CITY OF PUYALLUP Planning Division Approved Site Plan (253) 864-4165 MINIMUM SETBACK REQUIREMENTS Front Yard: 10 ft Rear Yard: 0 ft Interior Side Yard: Left: 0 ft Right: 0 ft Street Side Yard: N/A Zoning District: RM-CORE Permit #: PRMU20240285 Additional Conditions/Comments Staff: RNBrown Date: 05/07/2024 Front, rear, and side yard property lines shall be marked with string from surveying pins prior to footing inspection.

Sunset Garden Senior Living Apartments

SITE PLAN 236 UNITS 1" = 40'

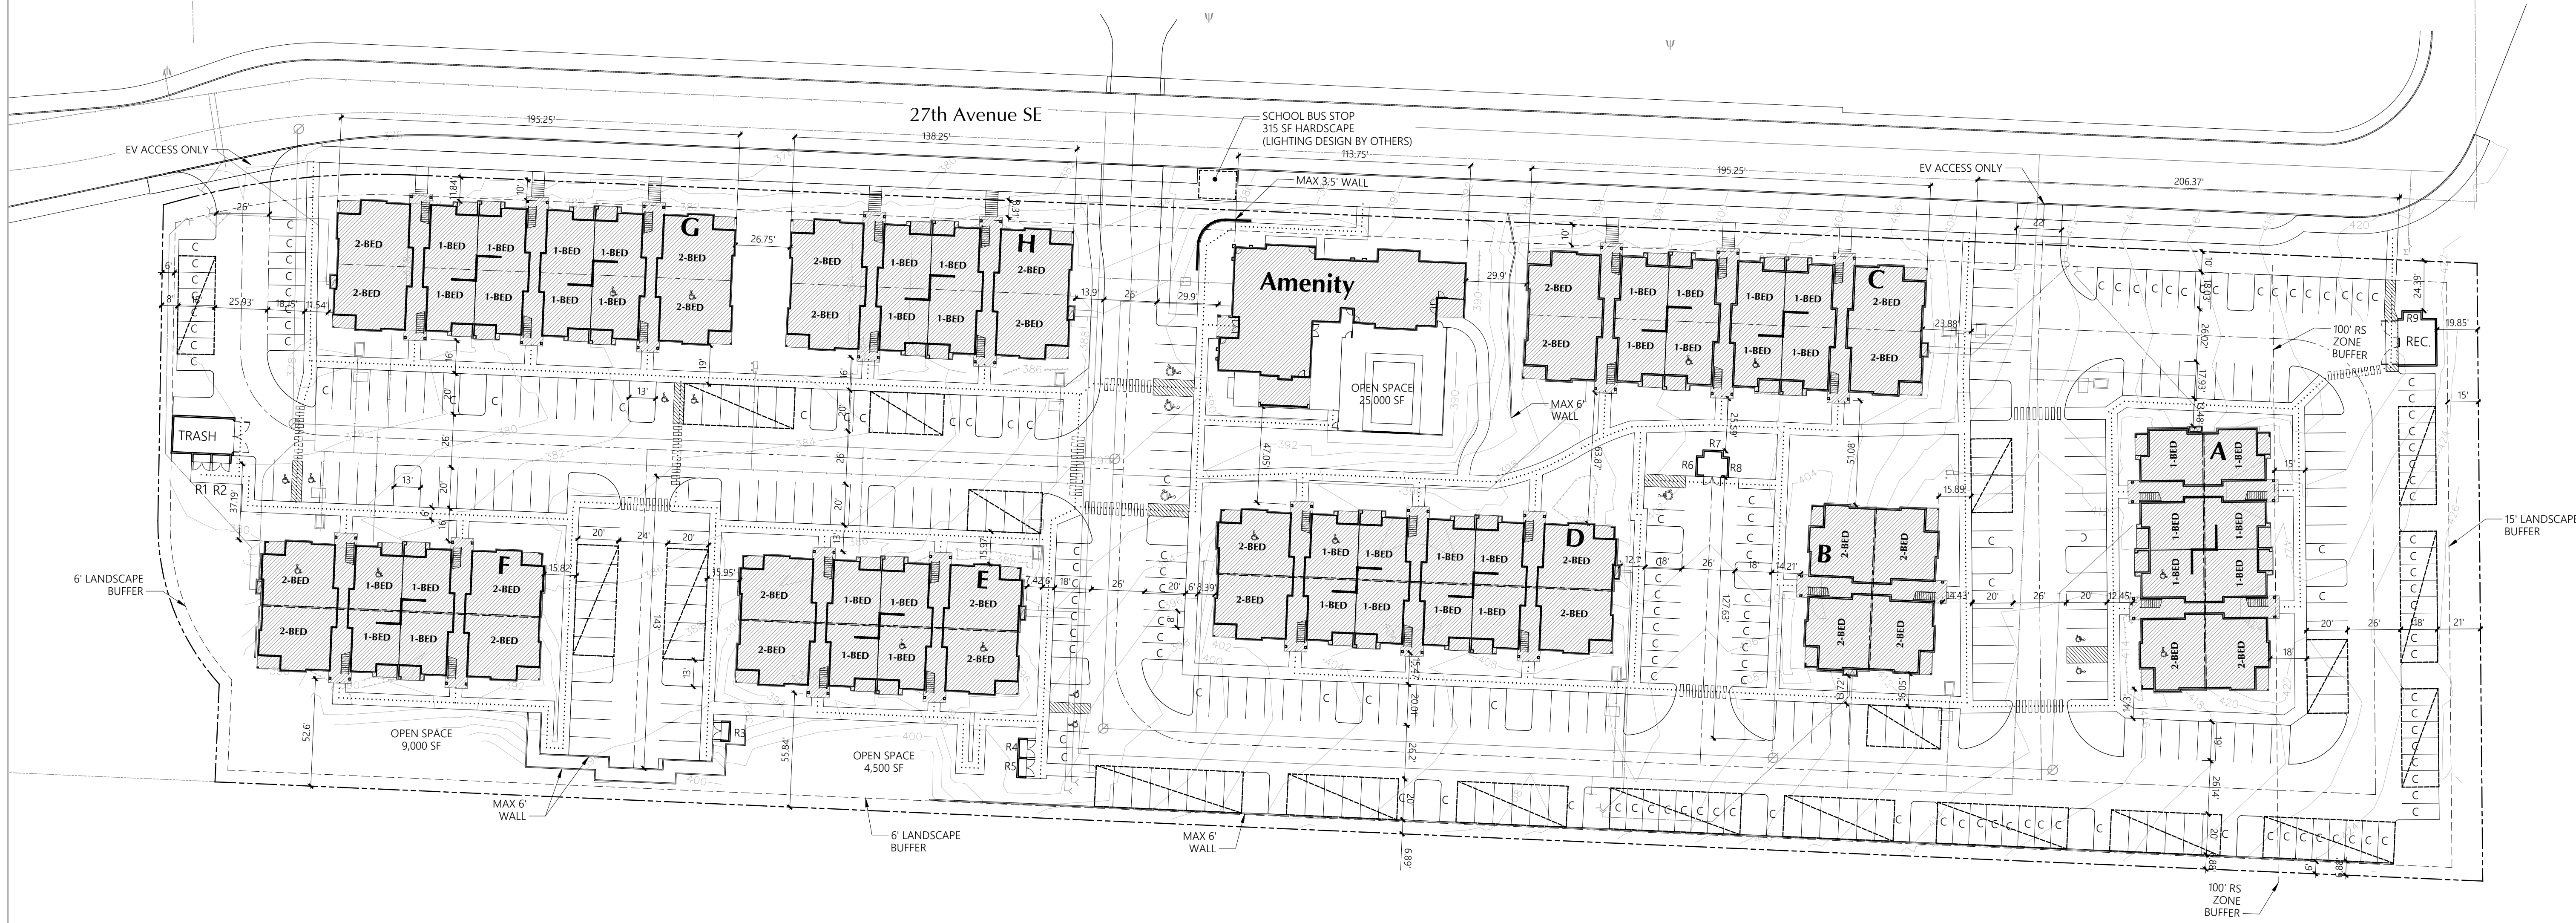
No EV parking calculations included in parking summary. Provide EV parking to meet Section 429 of the 2018 IBC WA Amendment. Page A2 - Site Plan

Incomplete site plan. Please refer to the CoP Site Plan Standards (available to download in the permitting portal). Revise the site plan to include items 1-3 and items A-X of the City's Site Plan Standards. Since the building permit cannot be issued until civil construction permit is issued first and the building plans must match the approved civil plans, please coordinate your final building permit submittal with the approval of the civil permit to avoid redundant or surplus building permit submittals and fees. [SITE PLAN, sheet A2]

Refer to the PRM20240278 corrections and address for all site plans associated with the Bradley Heights Apartments. [SITE PLAN, sheet A2]
